QUARANTINE NOTICE

Reference number:	QN-10-1127V2	Issued: 9 August, 2018
Subject:	Fuel filler latch	
Model(s):	Vantage 19MY	
VIN Range:	Refer to the separately published list of Vehicle Identification Numbers (VINs)	
Applicable to:	All Dealers	
Distribute to:	After Sales Manager Executive Manager Service Manager Sales Manager	Warranty Staff Technician(s) Parts Staff

Reason for Version 2 of this Service Action

Figure 1

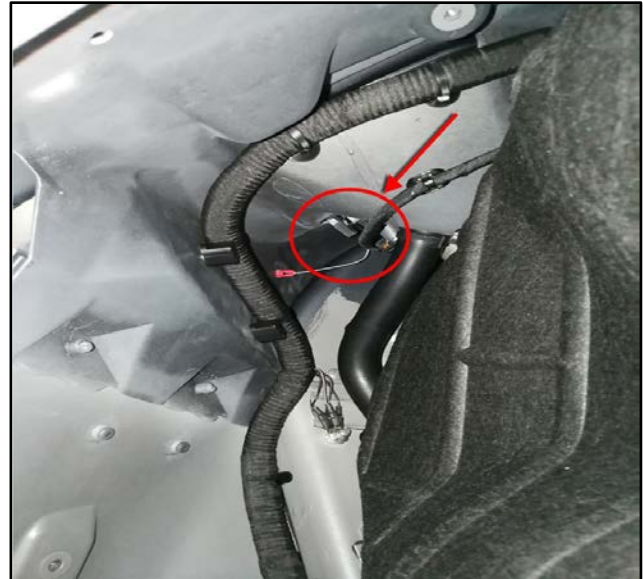
Aston Martin has found that the fuel filler latch mechanism can move out of position. If the fuel filler latch is not in the correct position the fuel filler door will not open or close correctly.

1. Remove the rear right-side wheel-arch liner (refer to Workshop Manual procedure 01.08.AK).
2. Remove the fuel filler latch from the clips that attach it to the vehicle body (refer to Figure 1).
